AMENDMENTS TO THE DRAWINGS:

REMARKS

TI-30961
1 of 5
09/703, 430

FIG. 5C

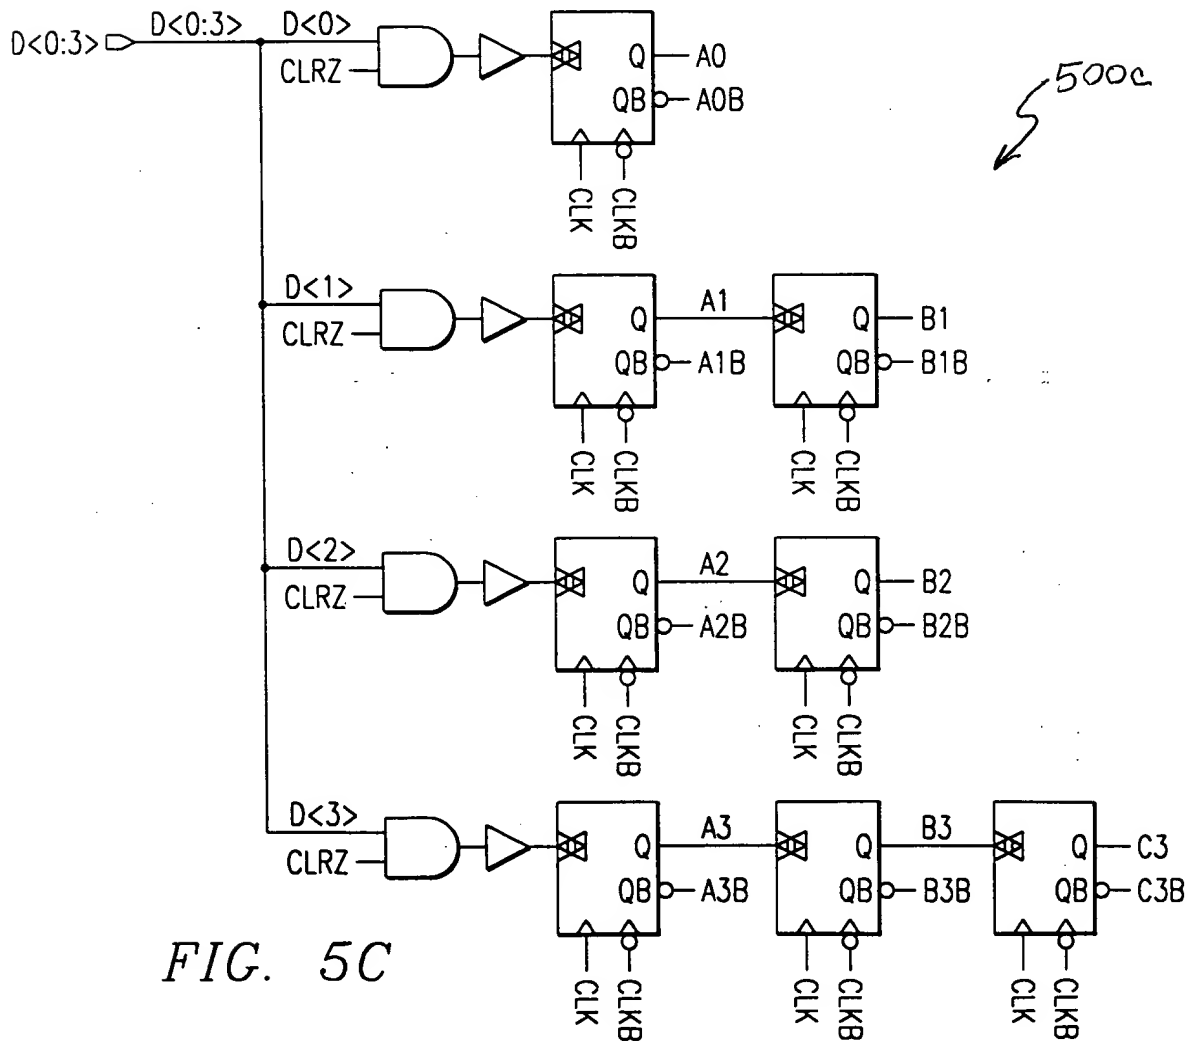
On Sheet 1, in Figure 5C, add the reference --500c-- with an arrow pointing to the circuit.

FIG. 4

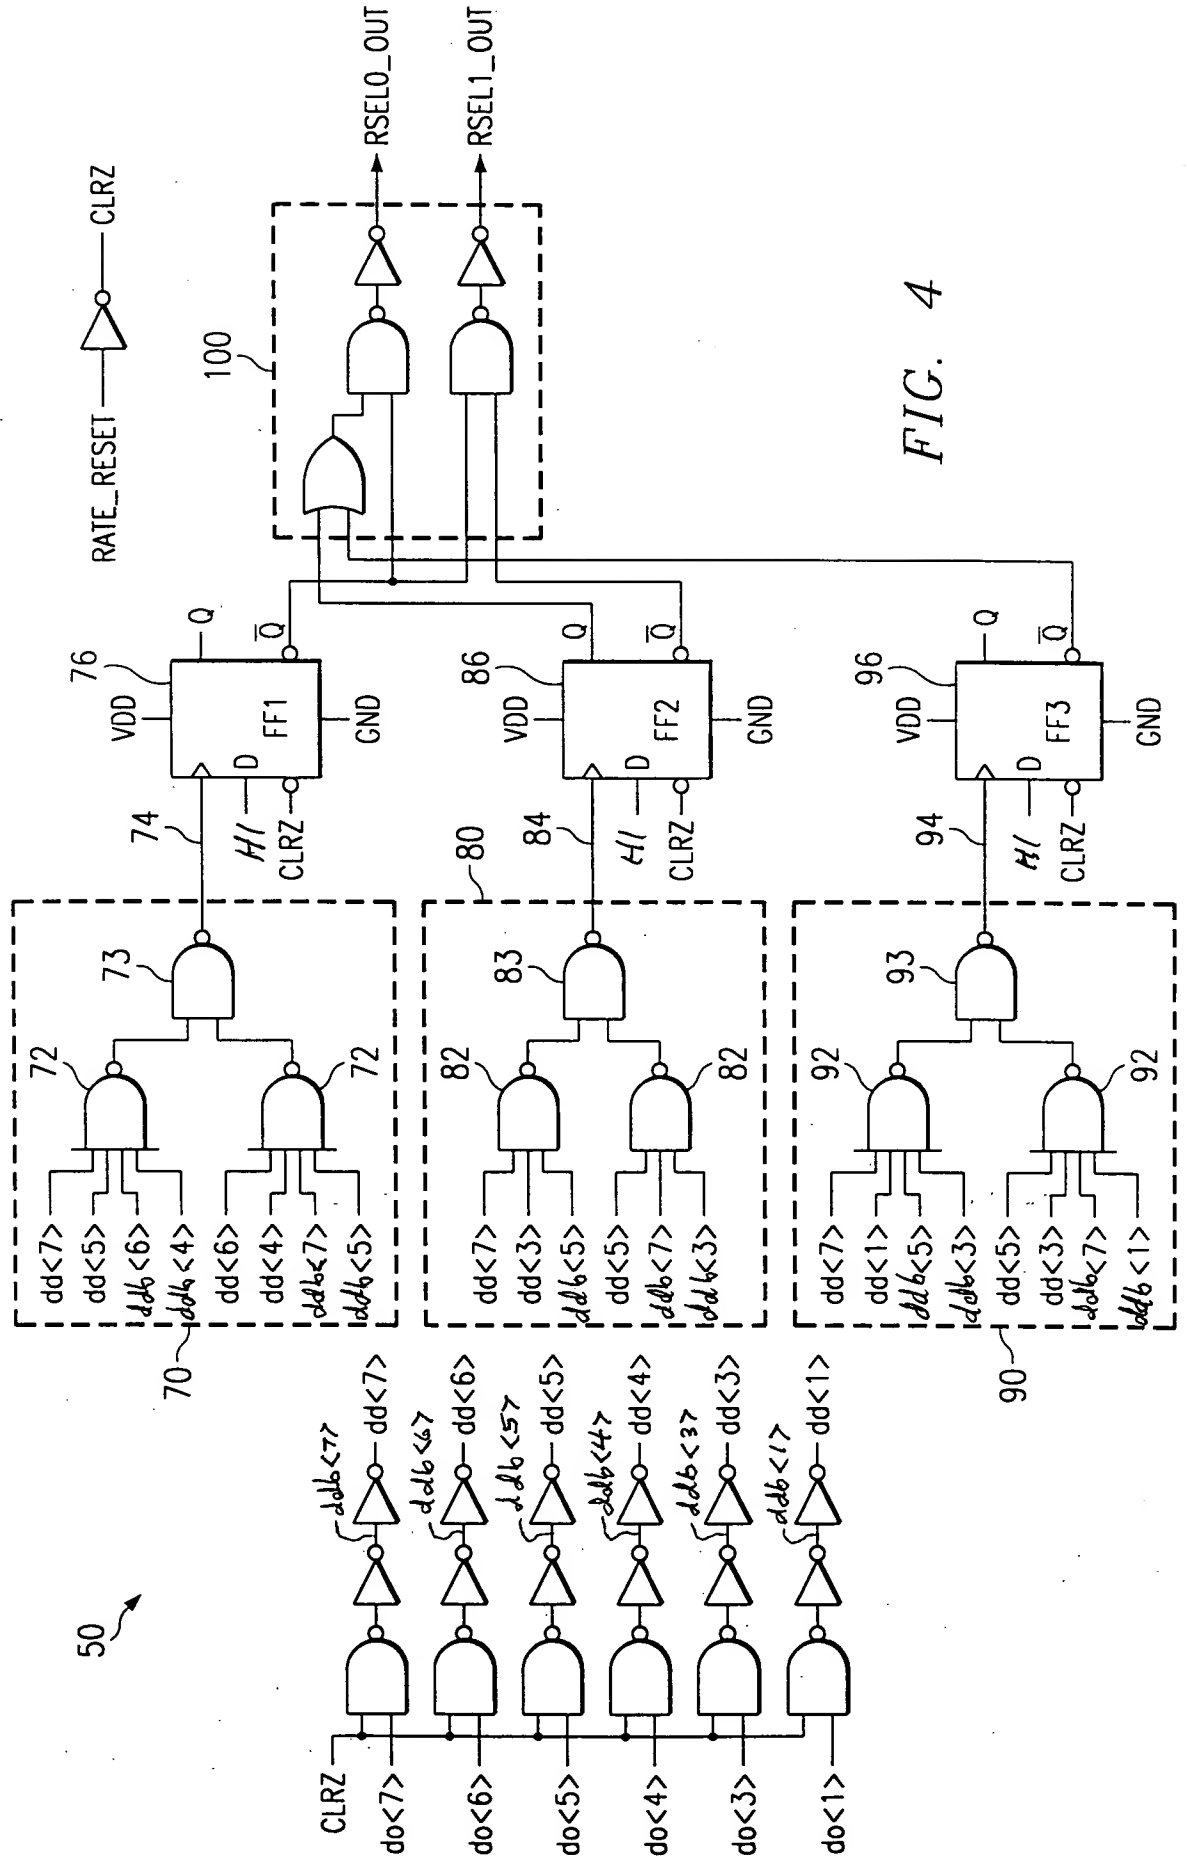
On Sheet 3, in Figure 4:

add --ddb<1>--, --ddb<3>--, --ddb<4>--, --ddb<5>--, --ddb<6>-- and --ddb<7>-- referring to the inputs of the inverters having outputs "dd<1>", "dd<3>", "dd<4>", "dd<5>", "dd<6>" and "dd<7>", respectively;

change "dd<4>" to --ddb<4>-- and "dd<6>" to --ddb<6>-- at the input of the upper NAND gate 72 in dashed box 70;

change "dd<5>" to --ddb<5>-- and "dd<7>" to --ddb<7>-- at the input of the lower NAND gate 72 in dashed box 70;

change "dd<5>" to --ddb<5>-- at the input of the upper NAND gate 82 in dashed box 80;

change "dd<7>" to --ddb<7>-- and "dd<3>" to --ddb<3>-- at the input of the lower NAND gate 82 in dashed box 80;

change "dd<5>" to --ddb<5>-- and "dd<3>" to --ddb<3>-- at the input of the upper NAND gate 92 in dashed box 90; and

change "dd<7>" to --ddb<7>-- and "dd<1>" to --ddb<1>-- at the input of the lower NAND gate 92 in dashed box 90.

FIG. 5A

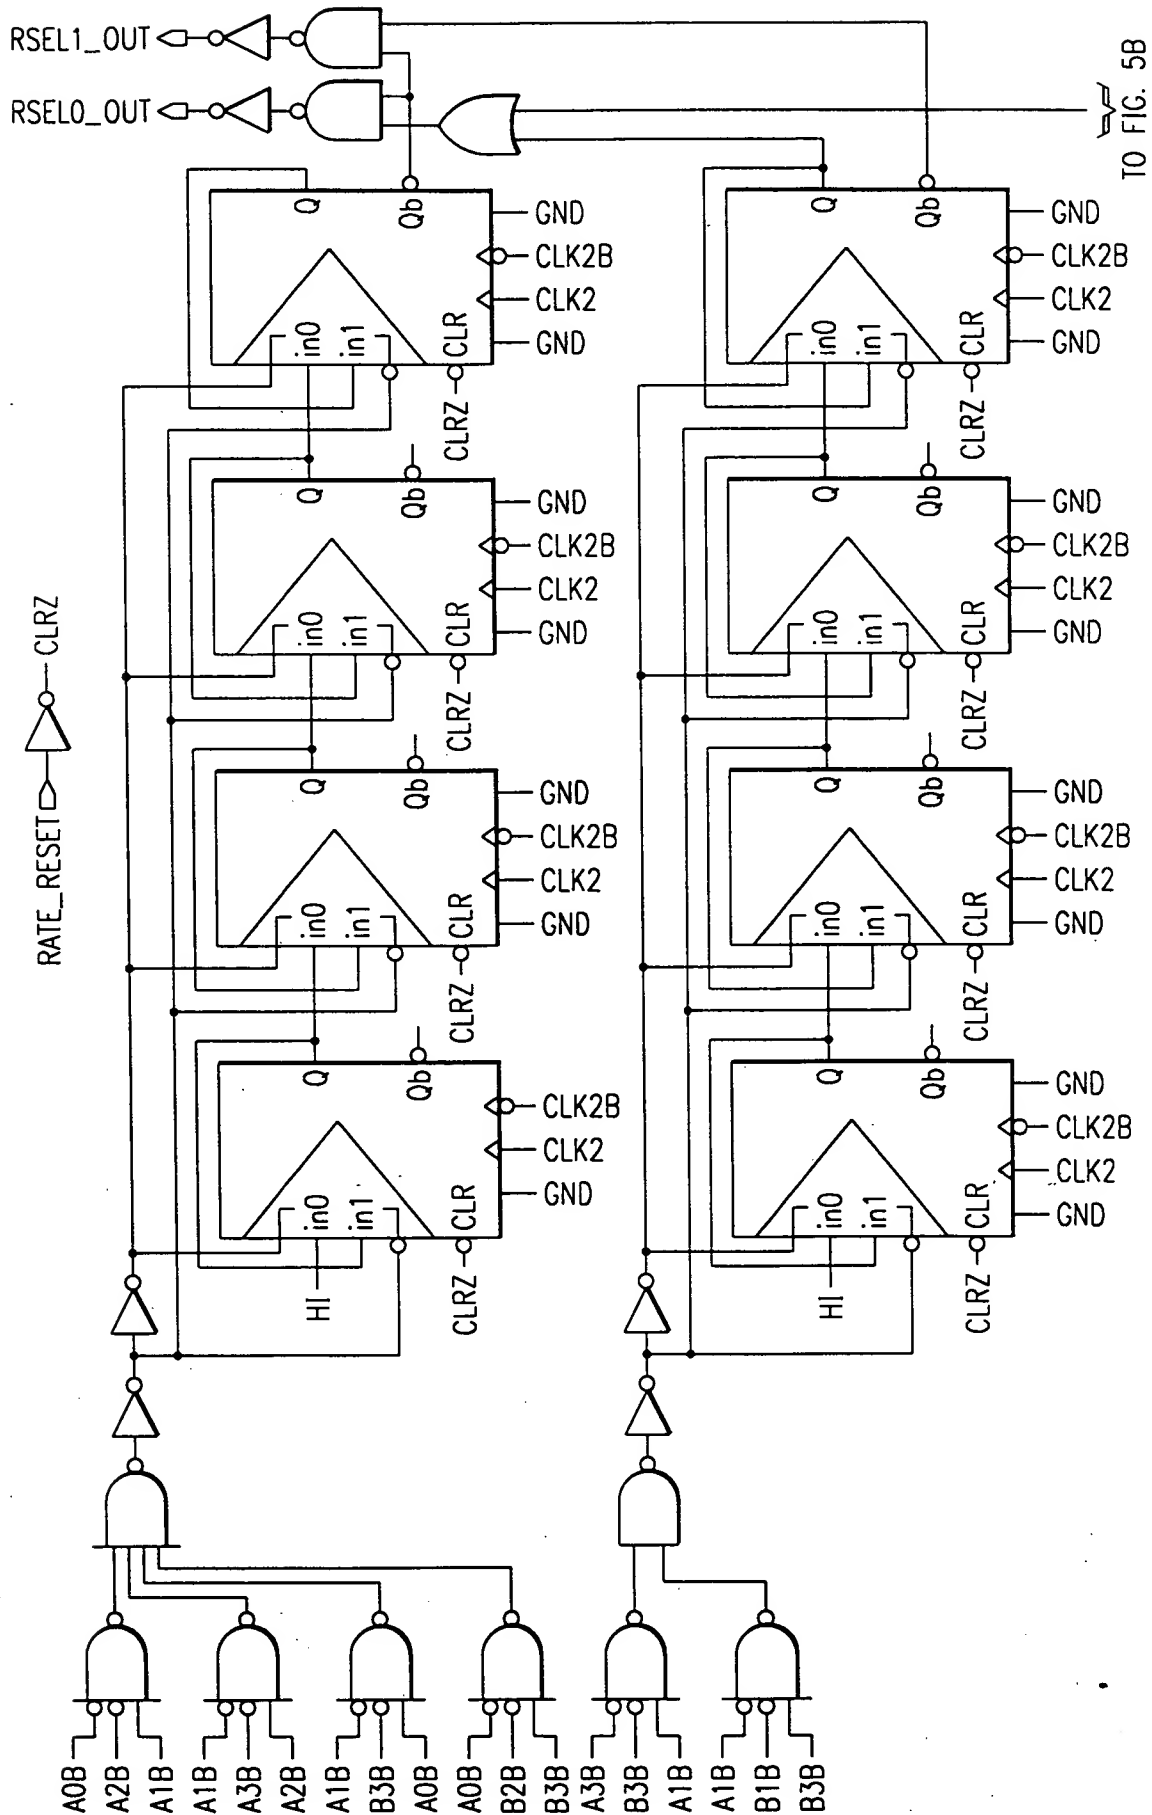
On Sheet 4, in Figure 5A, add the reference --500a-- with an arrow pointing to the circuit.

FIG. 5B

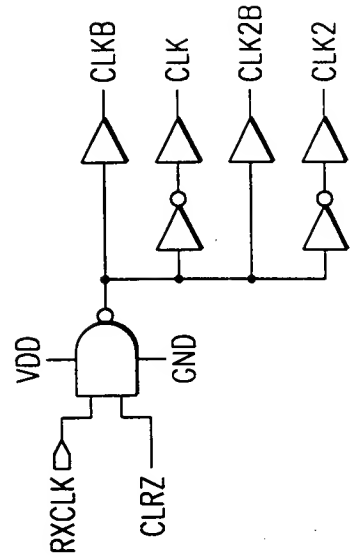
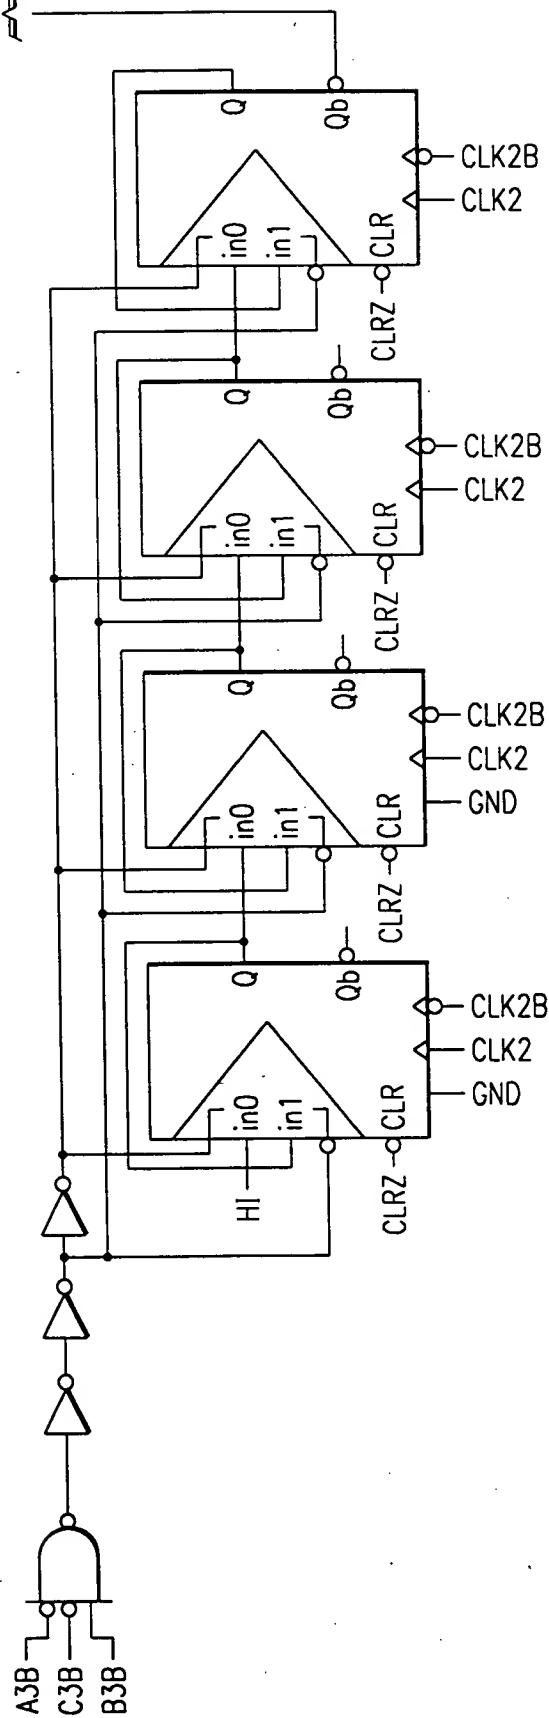
On Sheet 5, in Figure 5B, add the reference --500b-- with an arrow pointing to the circuit.
